**Addendum to Master Plan- H2 Land at Hallgreen, Inverbervie
Peterkin Homes Responses to Comments received from Aberdeenshire
Council 22/1/15 with regard to the Draft Hallgreen Master Plan**

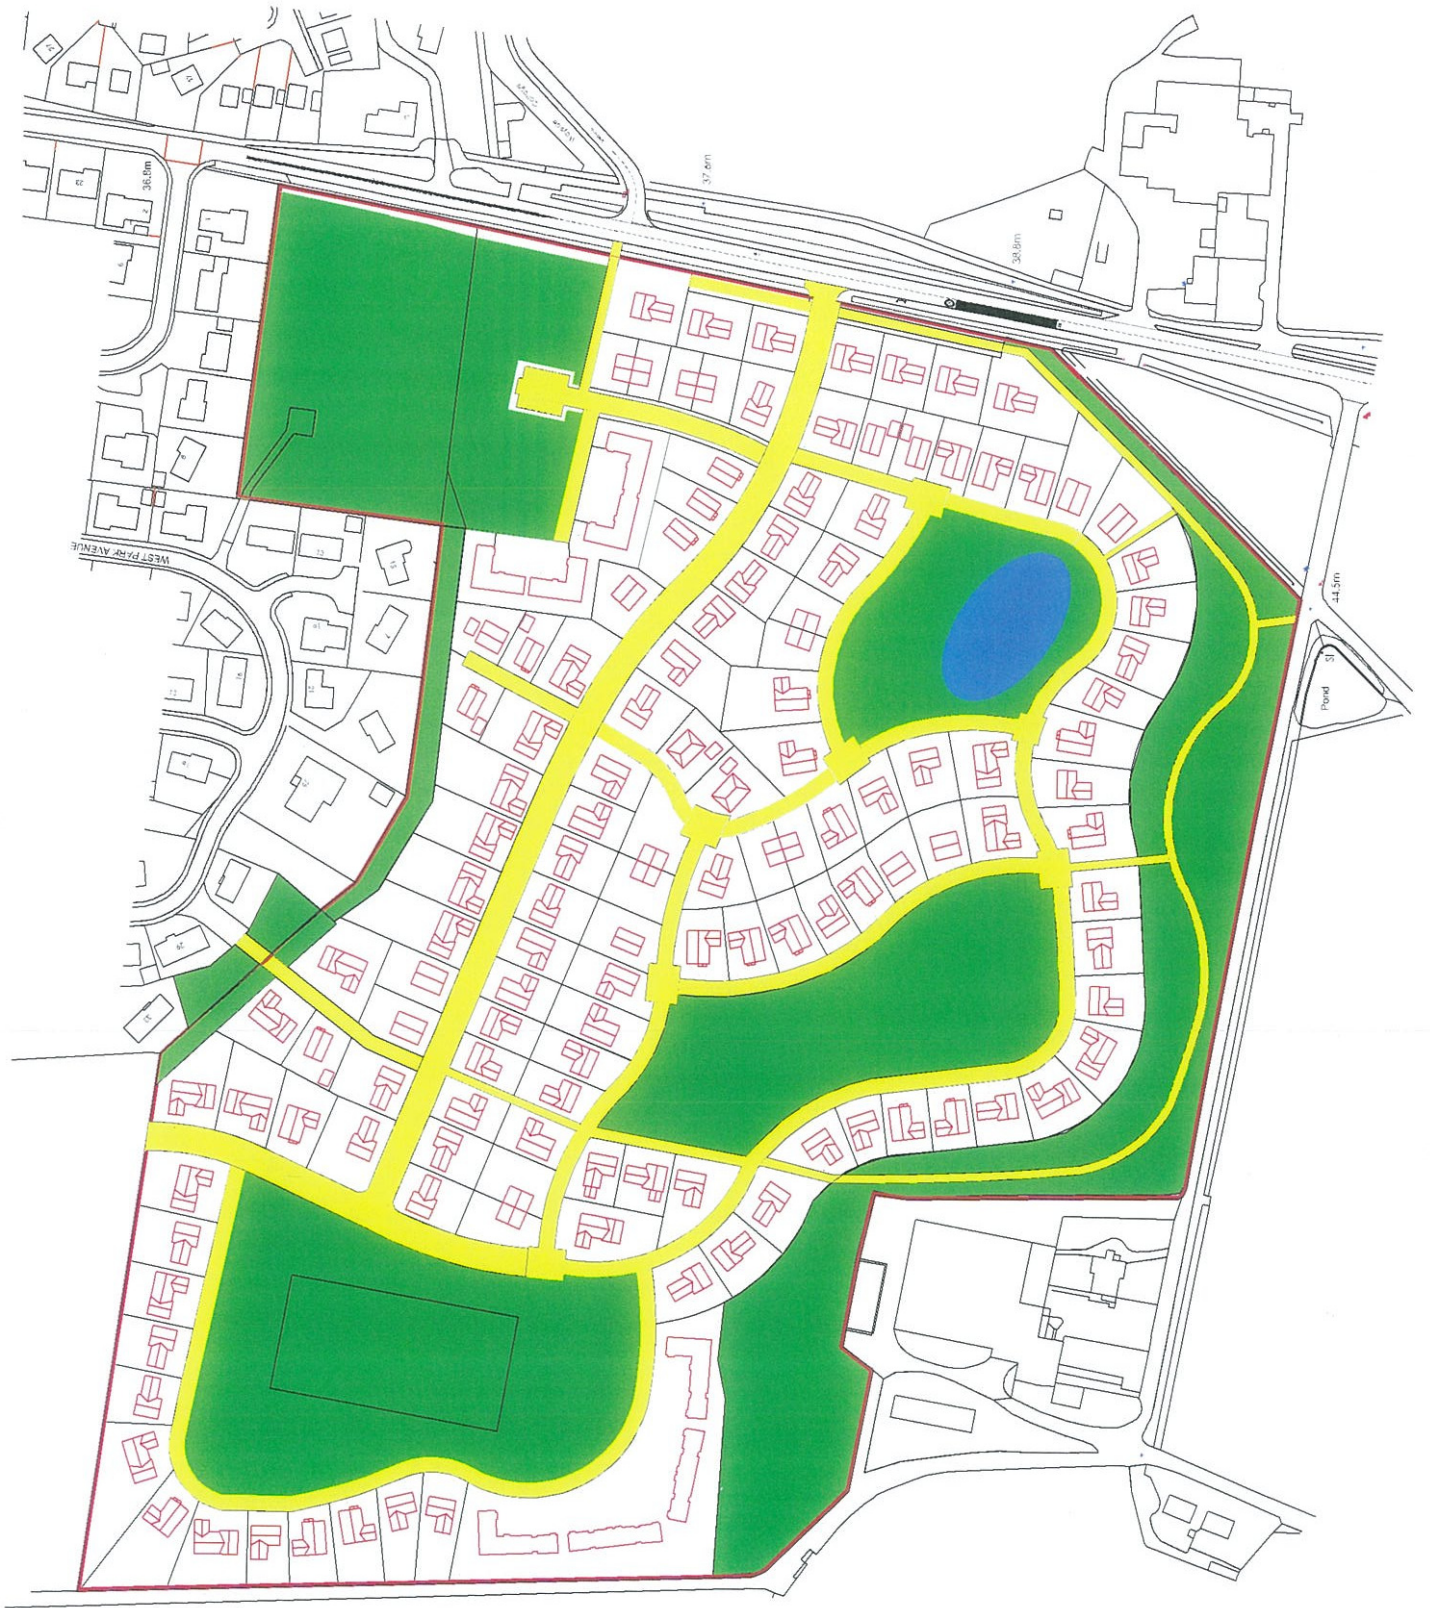
- Phasing plan required
- There is little detail or conceptual drawings on how the proposed layout has evolved as the best solution for this site.
- We note that the master plan incorporates existing play provision. As this facility serves existing needs it is important that this is not considered as part of the 40% open space requirement but is treated as an additional area
- The LDP identifies a requirement for open space contributions for allotments and a full size grass pitch. These should form part of the master plan and be delivered by the developer on site.

Response: Please refer to Plan HGI/2015/01 which provides the proposed phasing of the site. In terms of the evolution of the site design, Peterkin Home and their representatives have been in consultation with Aberdeenshire Council for over 15 months, during that time various layouts have been considered resulting in the layout which has been submitted as part of the Master Plan.
